DETAILED ACTION

Art Unit: 3723

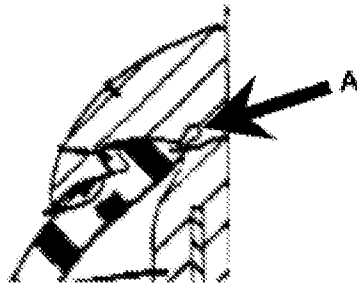
In reference to claim 24, Takahashi further discloses an embodiment (Fig. 2) wherein the socket (30) further comprises a notch base (A below) adjacent the socket (30) wherein the second longitudinal side of the bumper strip is held in an elastic flexed condition where the end of the second longitudinal side is located at a distance from the notch base.
